From: Polly Harris-Gorf
Sent: 05 May 2022 14:59
To: _planningadvice
Subject: FW: 21-L74 - PLOT 9 HOLBEACH - REF: H09-0253-22
Attachments: We sent you safe versions of your files; Visqueen_Radon_R400_Membrane_datasheet.pdf; 21-L74-PL006 - AJS - PROPOSED SECTION AND DETAILS.pdf

PLOT 9, HOLBEACH
SOUTH LINCOLNSHIRE FOOD ENTERPRISE ZONE

Drawing Title:
**PROPOSED OFFICE AND WORKSHOP
WITH ASSOCIATED WORKS
PROPOSED ROOF PLAN AND SECTIONS**

Drawing Number: **21-L74-PL006** Revision:

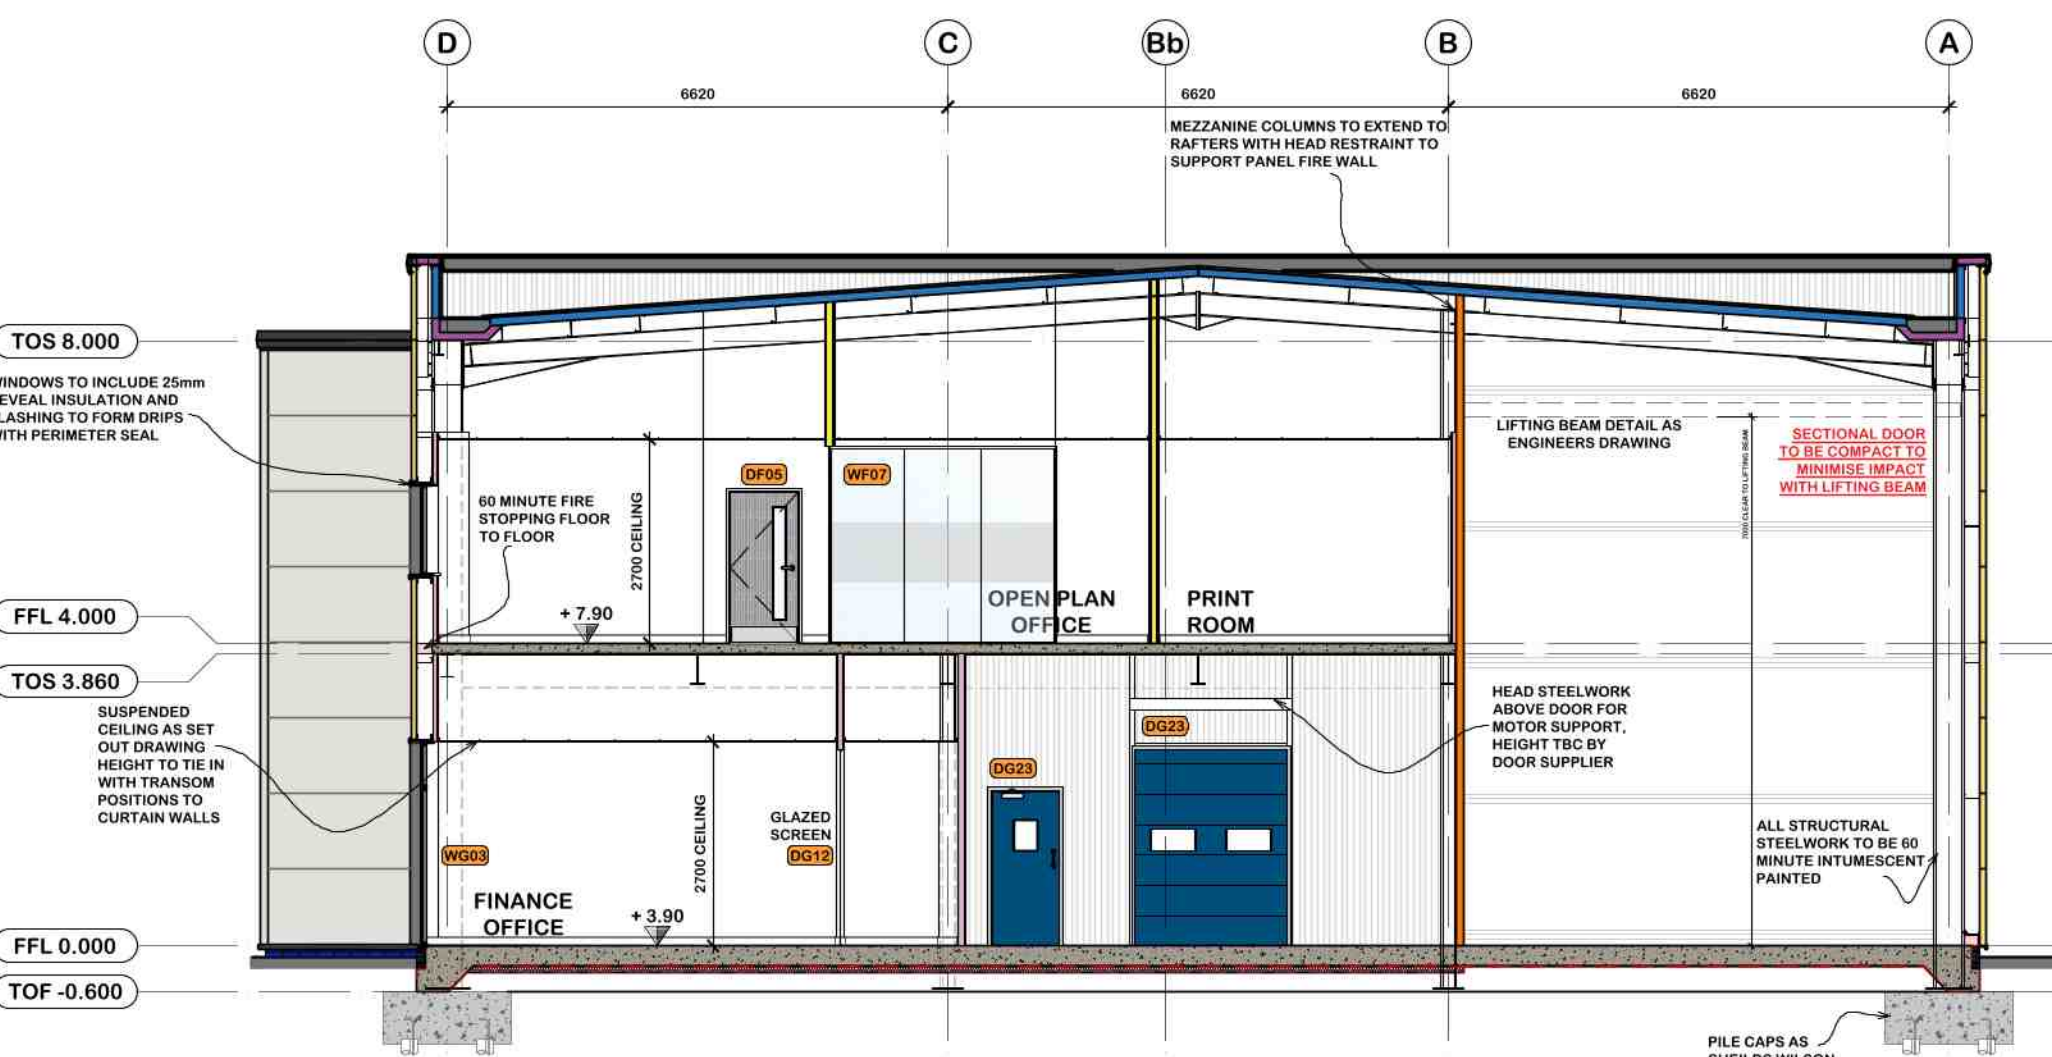
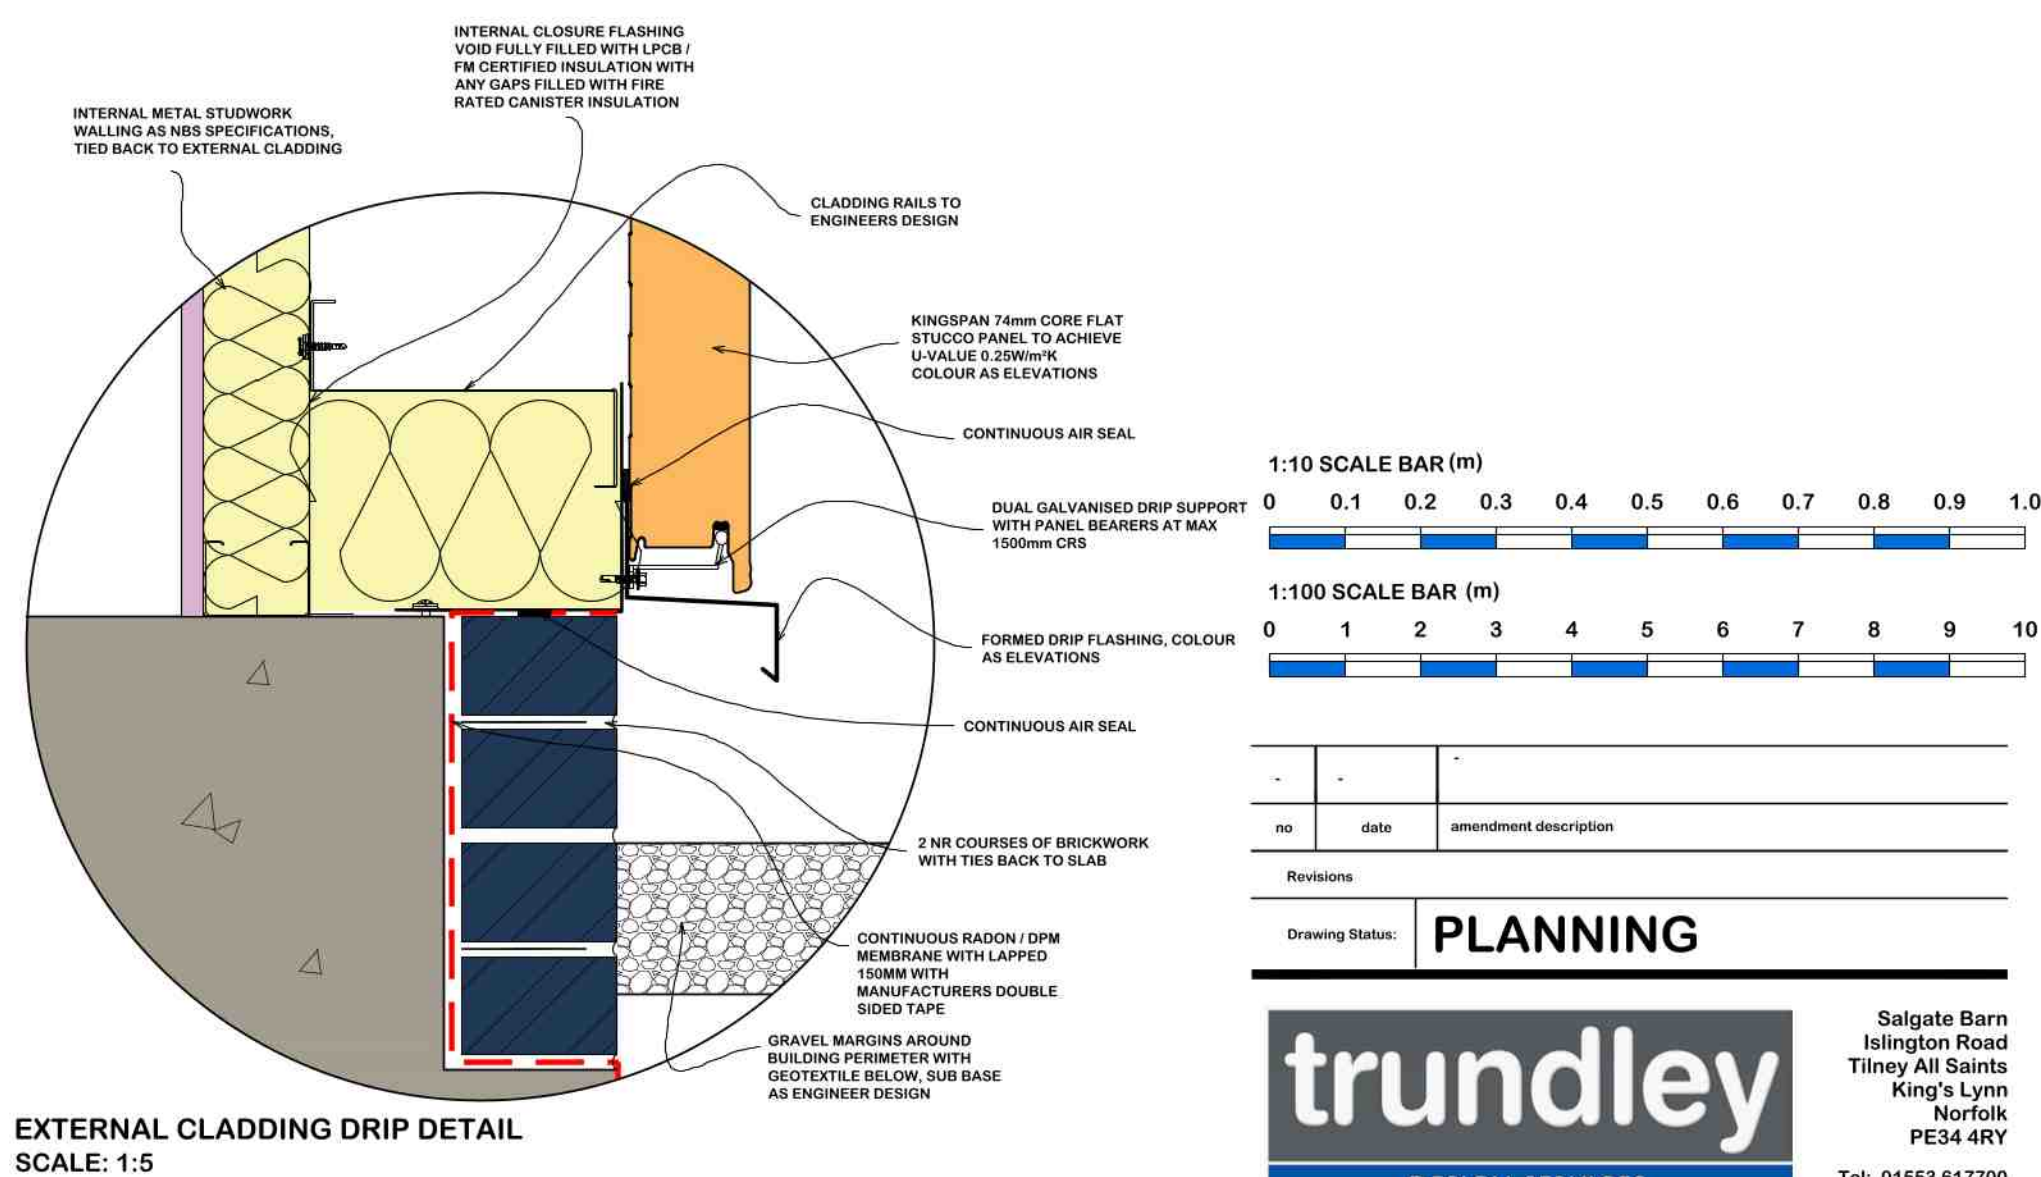
- Please could I see the slab edge/ wall detail?
- Exactly which membrane do they propose to use please?
- In order to achieve a score of 2 (Table 7 of BS8485:2015+A1:2019) for the membrane, it needs to be verified in accordance with CIRIA C735. Will this be undertaken please? I would expect that report to be submitted along with the delivery notes for the membrane and associated consumables (tape etc) as part of any validation report.

- **Item 1** - Please find attached drawing 21-L74-PL006 which will be a construction issue section drawing showing the extents of the Radon barrier dashed in red. The detail shown is to cover the full extents of the building footprint and is lapped up the perimeter slab as per the enlarged detail.
